DESCRIPTION
NPXY50 - SS - 286
2-AXIS SCANNER
XY 50um

NUMBER	REV.	SHEET
3715286	B	SHEET 1 OF 1

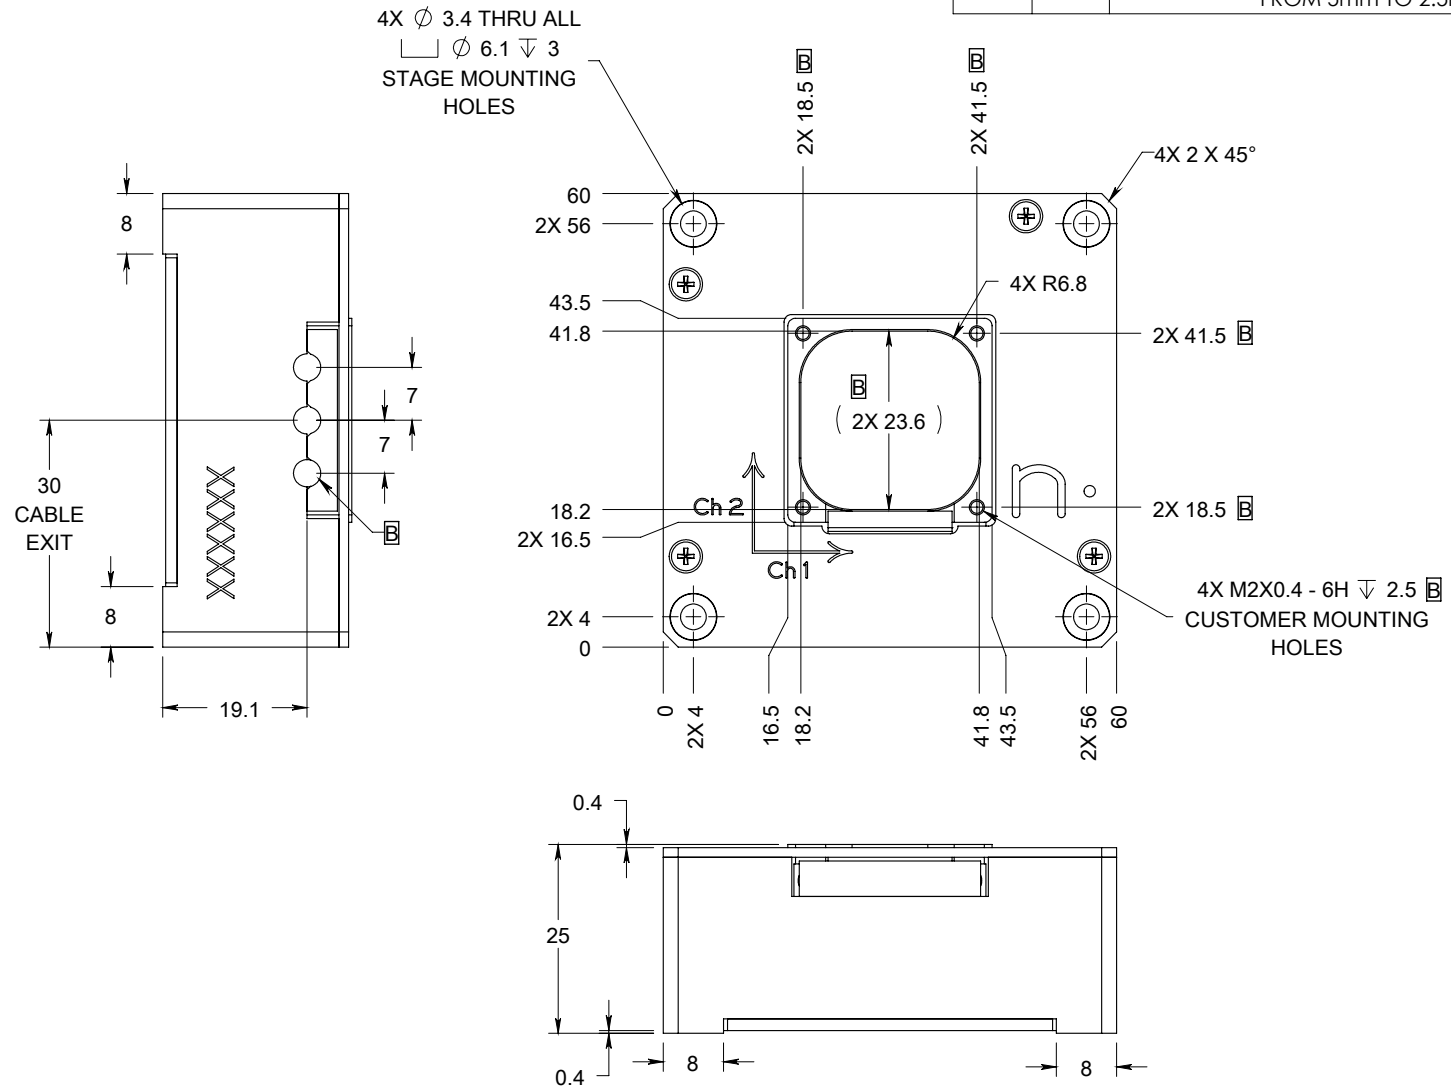
ZONE	REV	DESCRIPTION	DATE	BY	APP'D
B2, C2, C3, D2, D3	B	INCREASED APERTURE SIZE, ADDED CABLE EXIT (FOR XY50Z5 STAGE), INCREASED DISTANCE BETWEEN CUSTOMER MOUNTING HOLES, DECREASED CUSTOMER MOUNTING HOLE DEPTH FROM 5mm TO 2.5mm	1/23/2017	JF
